From: [Phil Mitchell](#)
To: [Adonica Giborees](#)
Subject: RE: Feedback on updated application & s92 response: proposed helipad at 38 Rawene Avenue, Westmere (LUC60389929)
Date: Tuesday, 11 June 2024 10:37:09 am
Attachments: [image001.gif](#)
[ATT00001.gif](#)
[Screenshot_2024-06-07_134717.png](#)

Subject: Feedback on updated application & s92 response: proposed helipad at 38 Rawene Avenue, Westmere (LUC60389929)

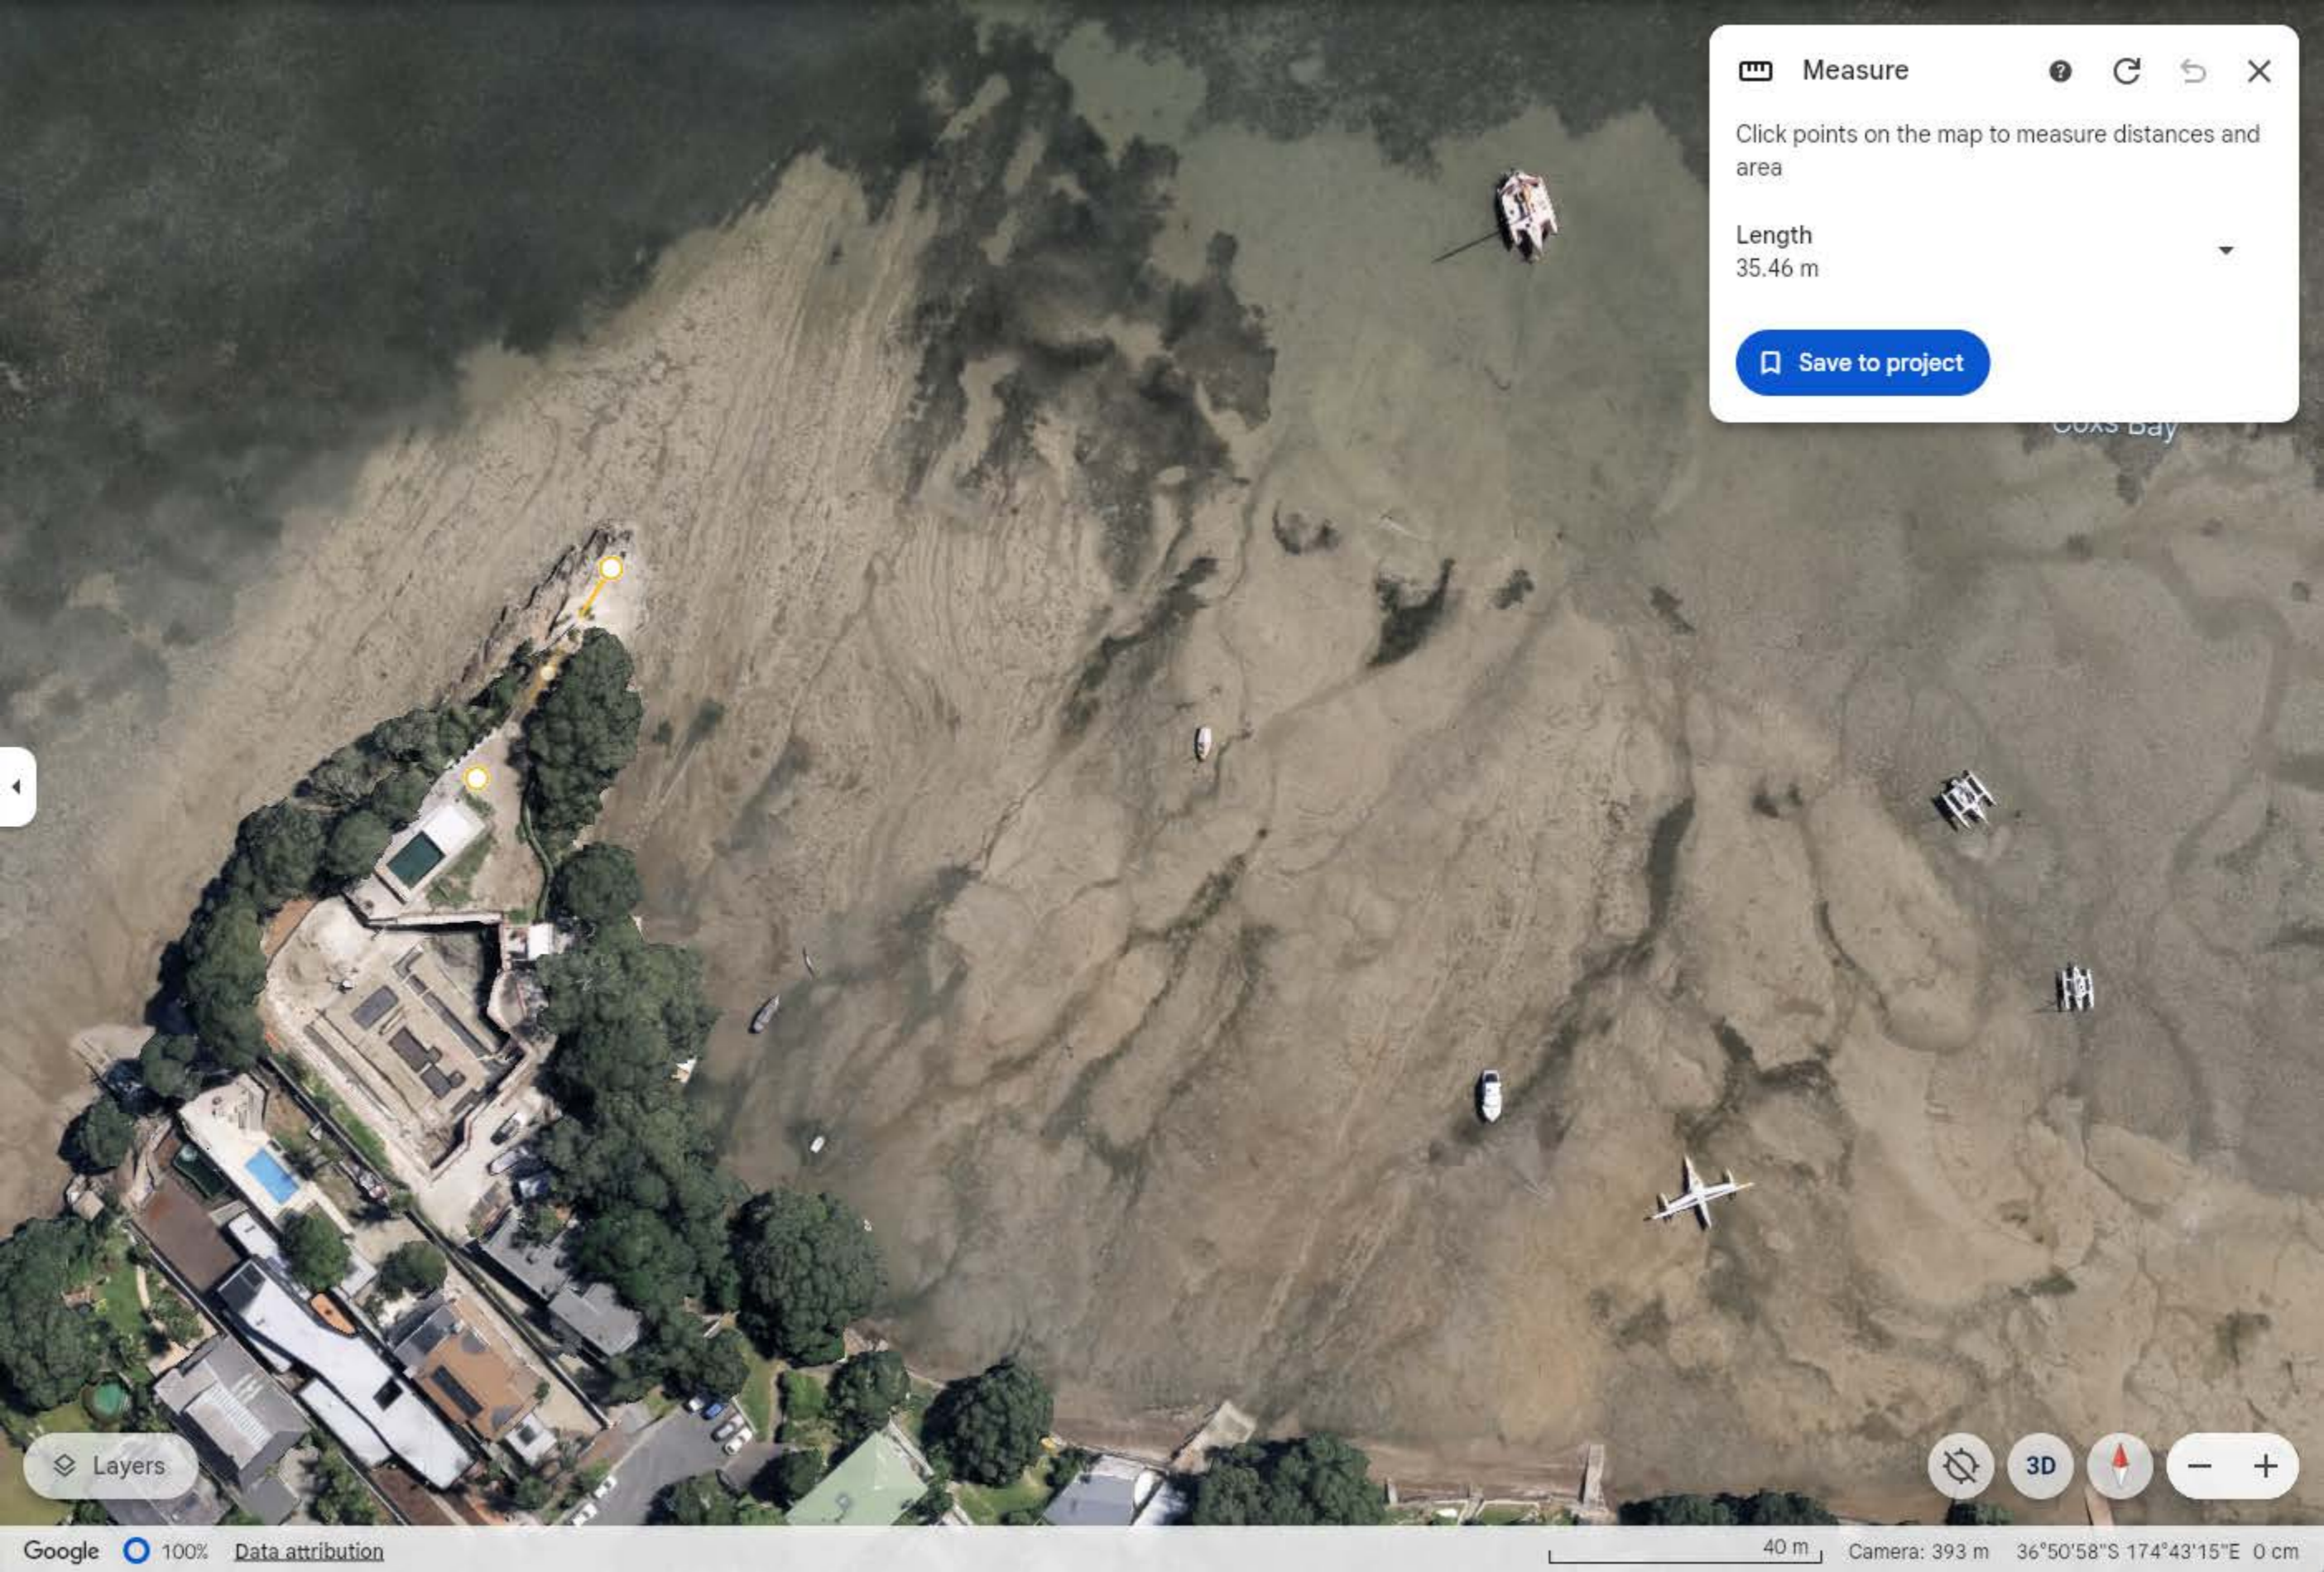
3. The Ecological Report and updated AEE do not mention how far away the

proposed Helipad is from the high tide bird roost. The AEE mentions the proposed helipad is 6m from and 6m above the planting for CST60383790, is this next to the high tide bird roost?

In response to your Question 3, the bird roost is approximately 35 meters from landing location with a 6m drop over that distance, as per the attached image.
